**THE GARDENS AT NORTH
CAREFREE
PRELIMINARY DRAINAGE REPORT
EL PASO COUNTY, COLORADO**

PROJECT NO. 187608744

August 3, 2018

Figure 2: Existing Drainage Map

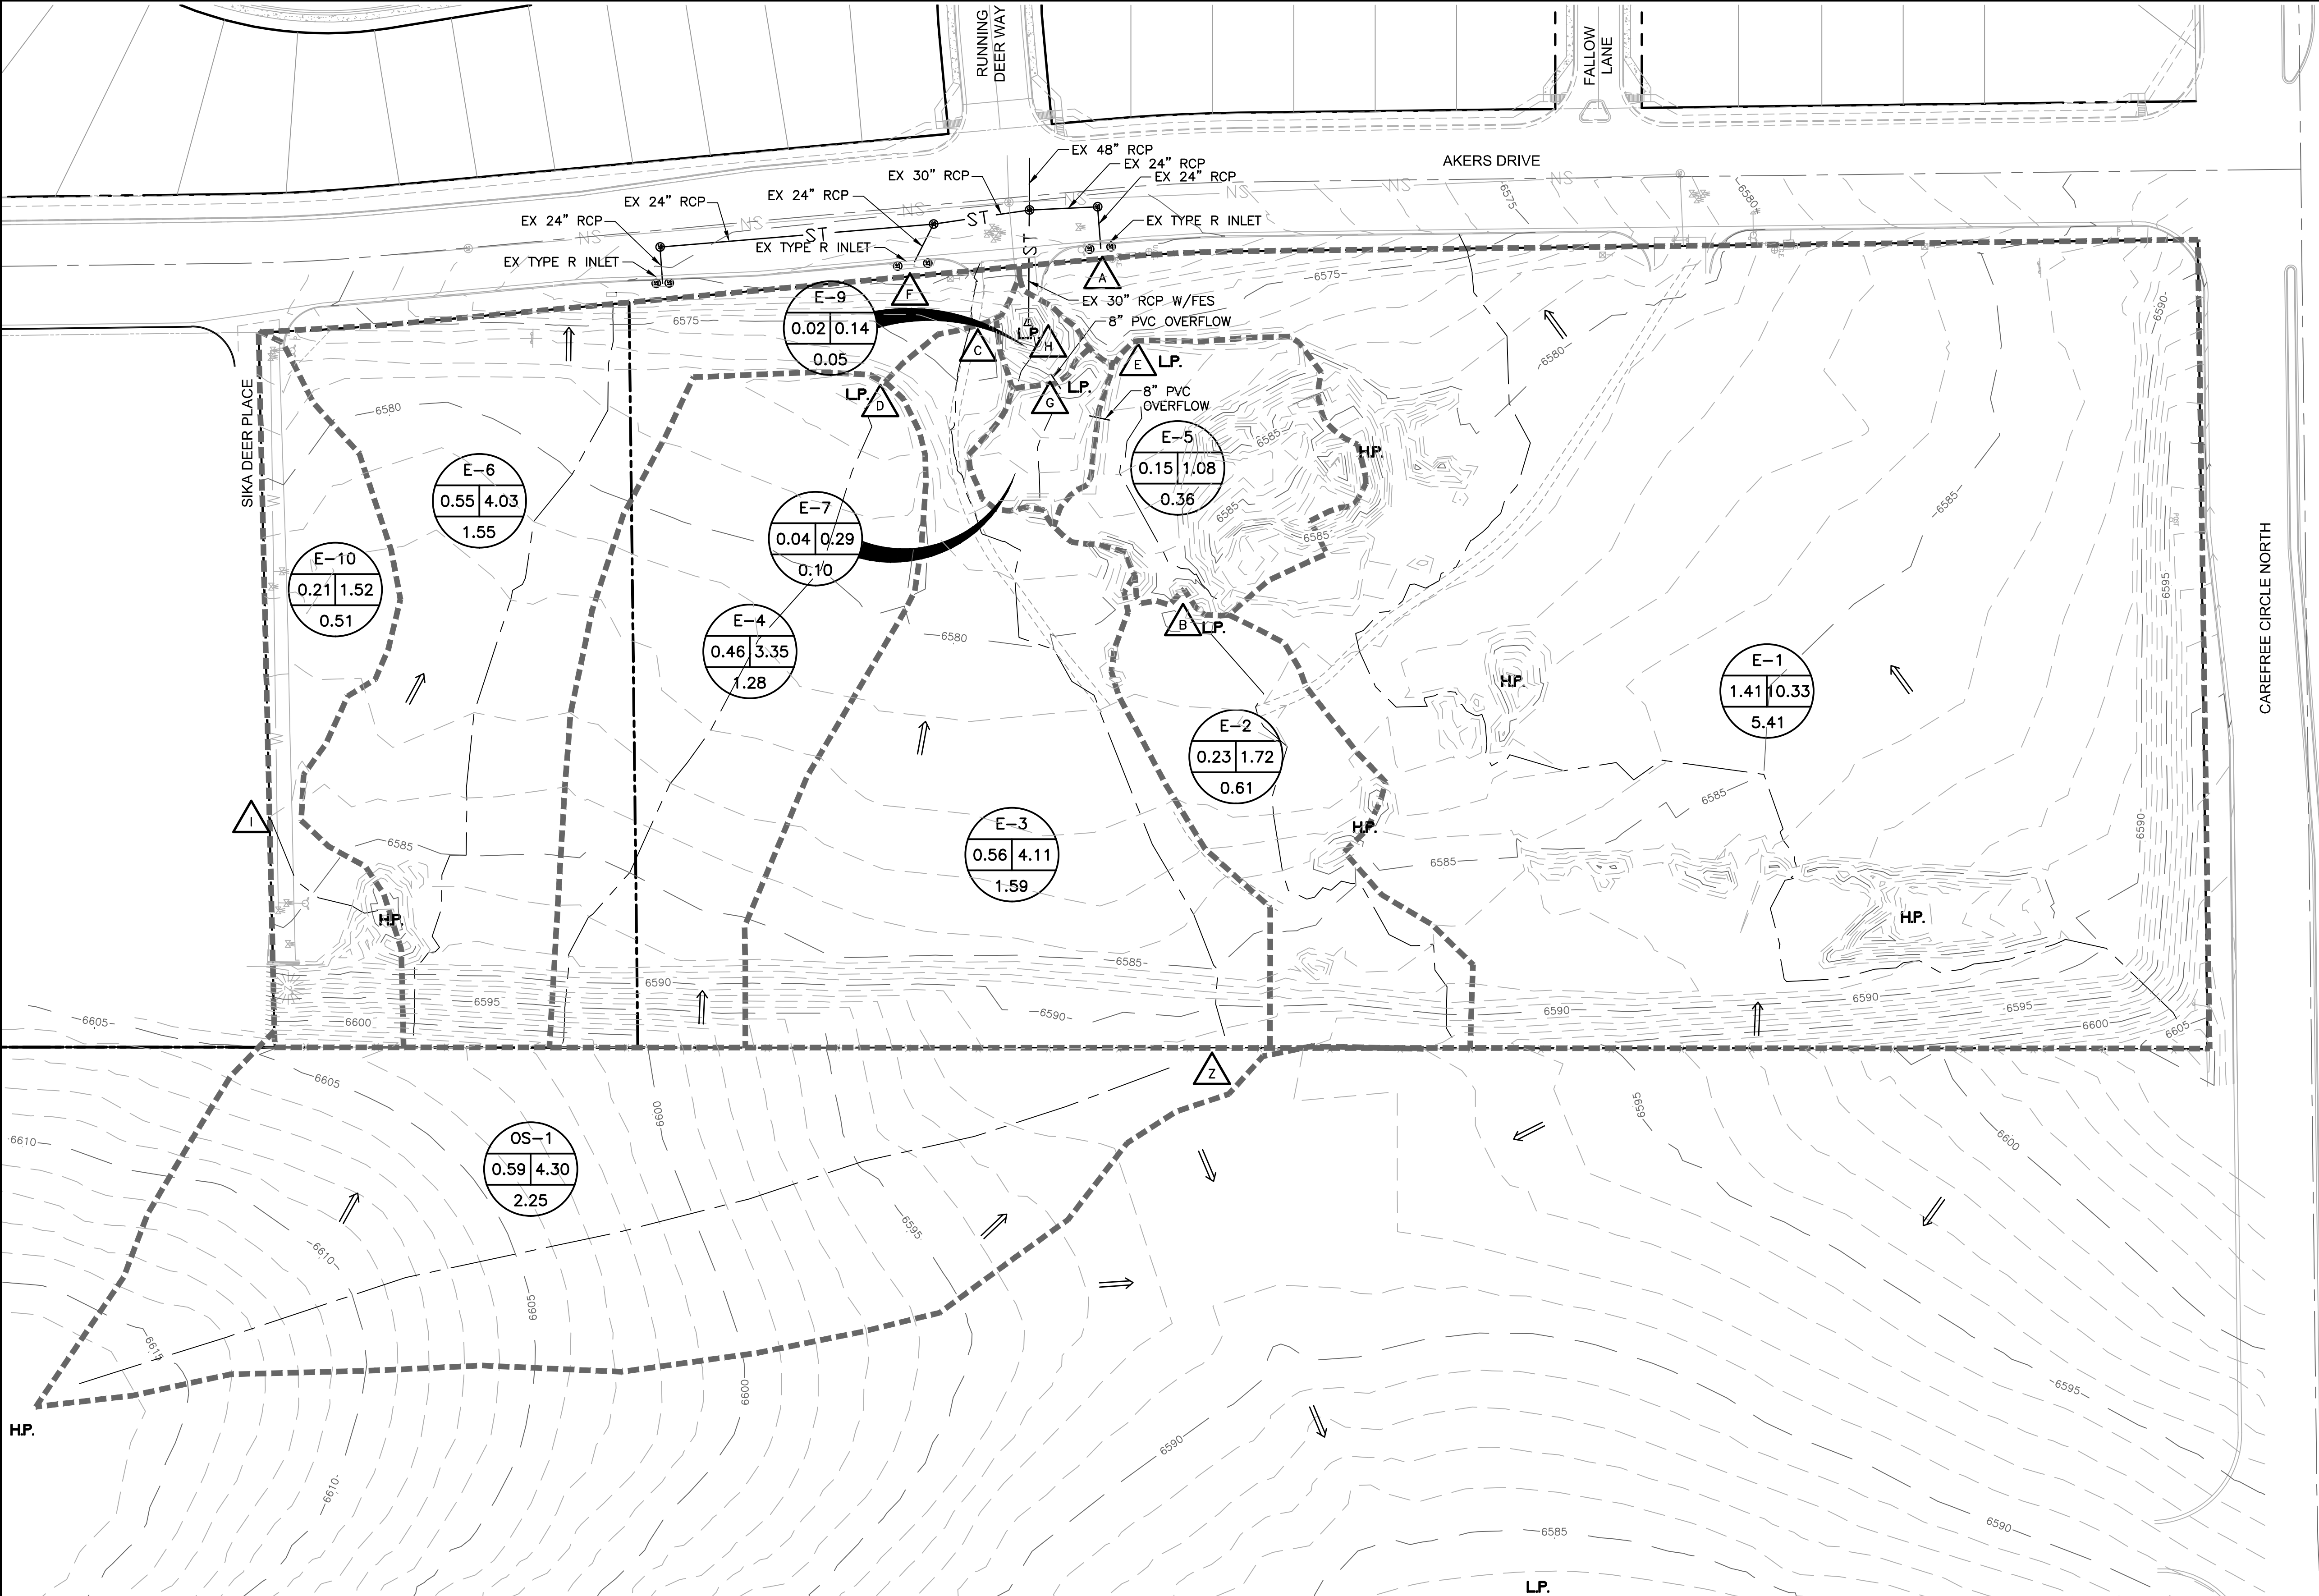
Basin E-12 is not on the existing drainage plan. It appears this is a typo.

Basin Reference changed

Figure 3: Proposed Drainage Map

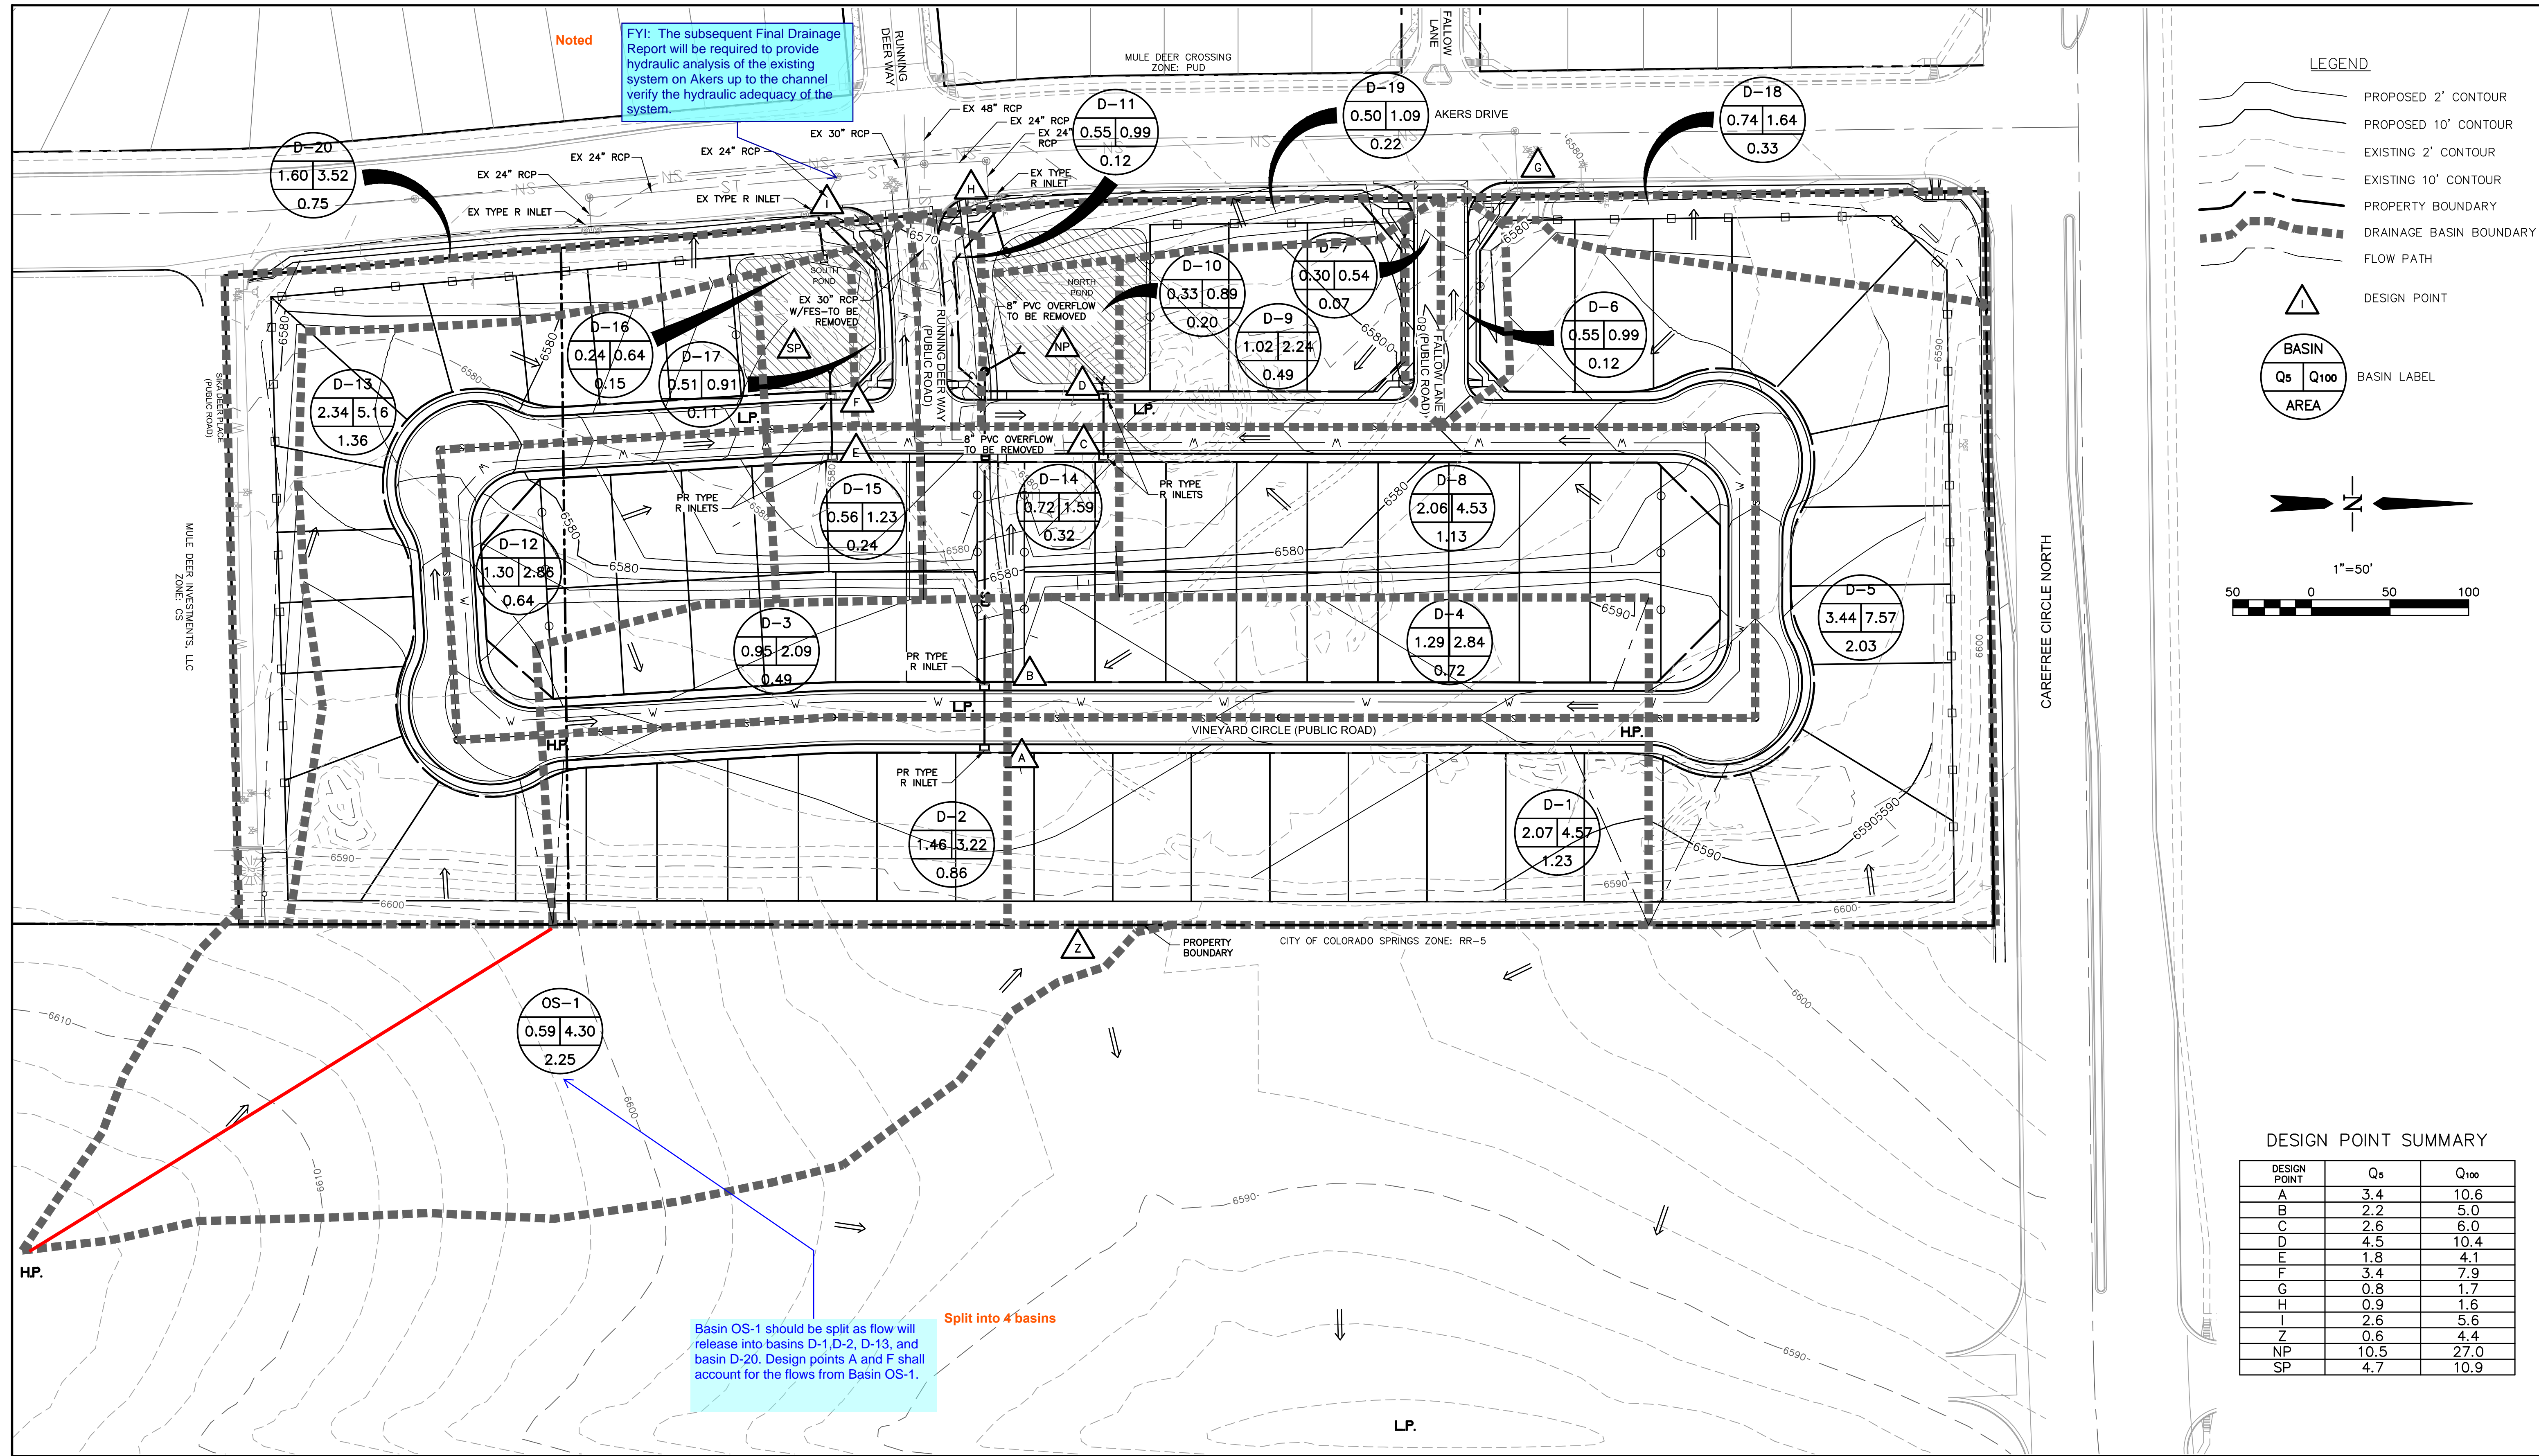
Elaborate. Is the plan to directly tie into the existing inlets on Akers Dr or to release at the surface which will then drain into the existing inlet.

Since improvements downstream has not been fully constructed provide Full Spectrum Detention (FSD) per current criteria. Update the narrative accordingly.

FYI: The subsequent Final Drainage Report will be required to provide hydraulic analysis of the existing system on Akers up to the channel verify the hydraulic adequacy of the system.
